Proposal for Supplement 15 to the 04 series of amendments to UN Regulation No. 44 (Child restraint systems)

Submitted by the expert from the European Association of Automotive Suppliers

Paragraph 6.2.12. amend to read:

Belt width measurement at slot plate

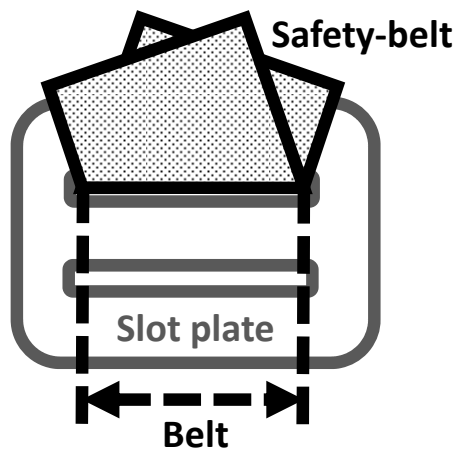
- (a) pass through the fixture points or belt guides of non-integral child restraint systems, or
- ~~(b) permit a lie of the belt that leads to any contact narrower than 38 mm between the adult belt or simulated buckle and the child, or~~
- (b) permit a lie of the belt within the slot plate that has a width narrower than 38 mm as described in the figure below:**
